Your Ref: 63 and 83 Church Street
Our Ref: LTR003-02-23-1102 - 63 & 83 Church Street Flood
Assessment Report Site 1 & 2

RE: 83 Church Street (Site 1) and 63 Church Street (Site 2), Parramatta
Flood Planning Statement for Planning Proposal

Table 1: Council Requirements, Responses to Previous DA and Current Status

Table 2: Response to advice received from Council

below (refer to markup of the figure provided by Council for location references):

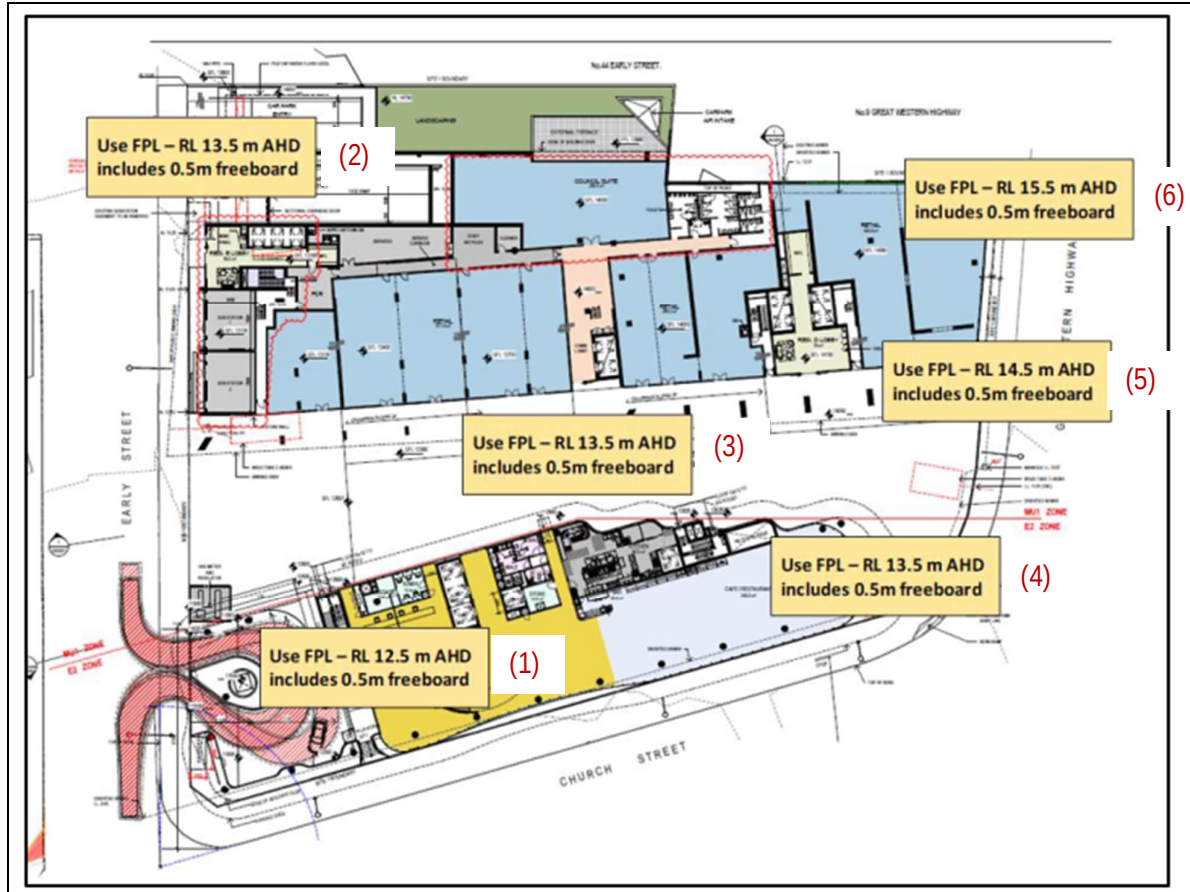
Council Advice	AT&L response
<i>It is noted that there are proposed changes to a number of the levels within the site (including the central plaza and the driveway).</i>	Council's advice in the Record of Pre-lodgement Application Meeting indicates varying FPLs across the proposed development. Comment regarding the adopted FFLs at each of these locations is outlined

You are advised that Council has new flooding information available which will need to be closely considered in your modification application.

There are indications that some parts of the site would not now comply with acceptable flood levels generated by overland flow and would be required to be raised. Other parts may be satisfactory.

However as no overland flow study has been carried out by the applicant this cannot be confirmed.

Offices and storage of valuable items including retail storage are unlikely to be acceptable below ground and below the FPL. Other proposed 'non-habitable' uses will be assessed on merit.

All habitable floors must be at or above the flood planning level which is the 1% AEP flood level plus 500mm freeboard.

Pending adoption of Council's Flood Study, the following levels identified as Flood Planning Levels (FPL) may be used for this purposes of this application. Minimum finished floor levels of habitable rooms should be considered in the design.

(1) Hotel Lobby

The adopted hotel lobby FFL is 12.90 mAHD (400mm above the FPL as per Council's recent advice).

(2) Residential Lobby

The adopted FFL of the residential lobby is 14.00 mAHD (500mm above the FPL as per Council's recent advice).

(3) Retail fronting Colonnade

The FFL of the retail spaces fronting the colonnade are proposed to vary between 13.40 mAHD and 14.00 mAHD (compared to a FPL as per Council's recent advice of 13.50 mAHD). The FFL of the two western-most retail spaces would be nominally 100mm below the FPL. As this part of the development is non-habitable the DCP requirements relating to floor level are not applicable.

(4) Café / Restaurant

The adopted FFL of the Café / Restaurant is 12.90 mAHD, which is 600mm below the FPL as per Council's recent advice. As this part of the development is non-habitable the DCP requirements relating to floor level are not applicable.

(5) Retail fronting Colonnade near Great Western Highway

The FFL of the retail space fronting the colonnade near GWH is 14.35 mAHD (compared to a FPL as per Council's recent advice of 14.50 mAHD). As this part of the development is non-habitable the DCP requirements relating to floor level are not applicable.

A detailed assessment will be undertaken to confirm the need or otherwise for flood barriers at the Residential E Lobby to address the risk of flood flows into the basement via the four residential lifts.

(6) Retail fronting Great Western Highway

The FFL of the retail spaces fronting the colonnade near GWH are 14.82 mAHD and 15.25 mAHD (compared to a FPL as per Council's recent advice of 15.50 mAHD). As this part of the development is non-habitable the DCP requirements relating to floor level are not applicable.
